SERVICE BULLETIN RELEASE - 07/11/2014

09-031/14 - 2013 CX-5 - RUBBER PROTECTOR PARTIALLY COMES OFF SIDE STEP MOLDING CAUSING A POOR APPEARANCE CONCERN

Subject: RUBBER PROTECTOR PARTIALLY COMES OFF SIDE STEP MOLDING CAUSING A POOR APPEARANCE CONCERN	Bulletin No: 09-031/14
	Last Issued: 07/11/2014

REPAIR PROCEDURE

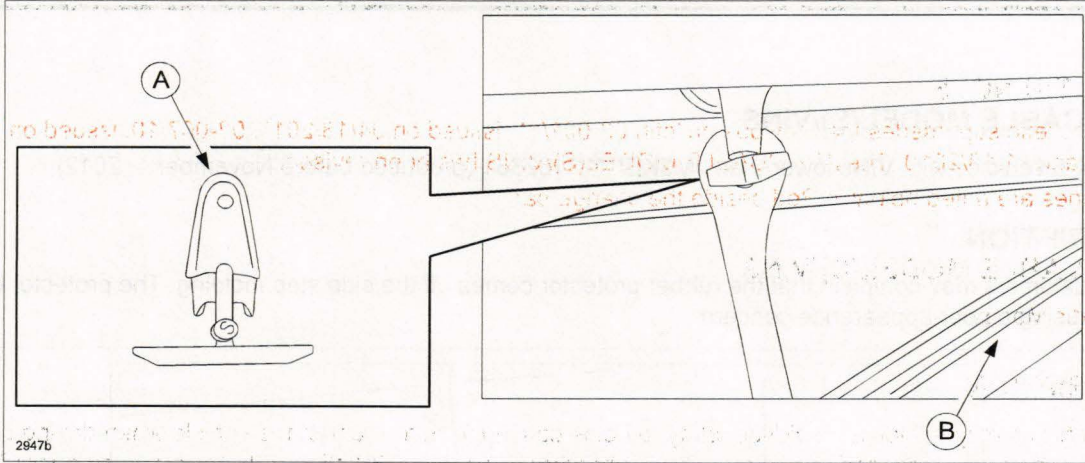
Some customers may complain that the rubber protector comes off the side step molding. The protector hangs down causing a poor appearance concern.

This concern may occur when the vehicle is driven in freezing temperatures. Snow and moisture adhere and freeze onto the rubber protector and when the door is opened, the rubber protector can tear or stretch, coming off the fasteners.

The material of the rubber protector around the fasteners has been changed to increase the holding force to the fasteners.

1. Verify customer concern.
2. Remove the twelve (12) fasteners (A) and rubber protector (B) using a fastener remover.

3. Install a new rubber protector.
4. Repeat the repair on the opposite side of vehicle as necessary.
5. Verify repair.
